Seismic Hazard and Screening Report (Example Submittal for CEUS Site)

Comment [C1]: Our focus on developing this example is primarily on Sections 2, 3, and 4, which describe the hazard evaluation and screening process. The example is for a plant that closely follows the SPID and the site response method described in Appendix B.

Figure 2.3.5-1. Median amplification as a function of frequency for the *Plant* site. Results for input bedrock amplitudes of 0.01, 0.3 and 1.5g are shown.

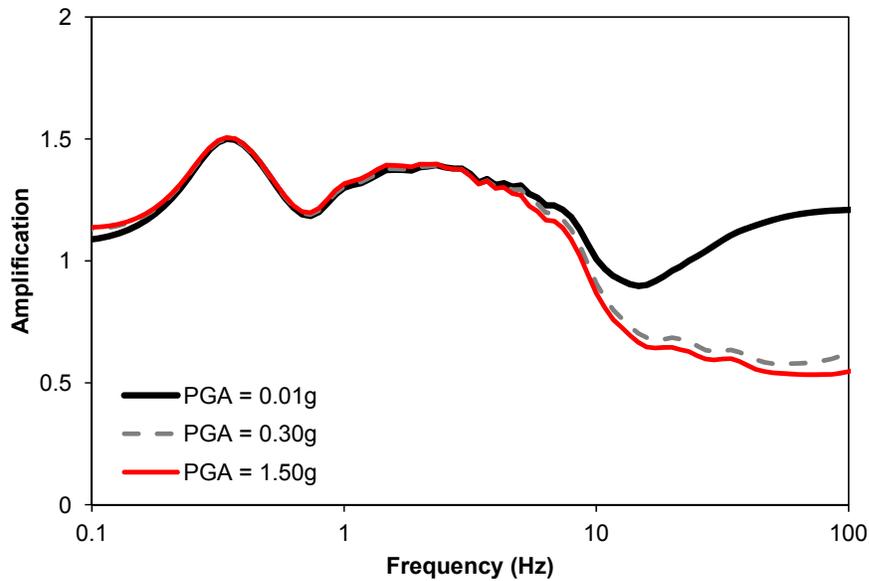
Comment [C6]: Robin to provide example figures for Amp functions. Staff expressed concern with not having Amp functions for entire frequency range instead of just seven used for GMM.
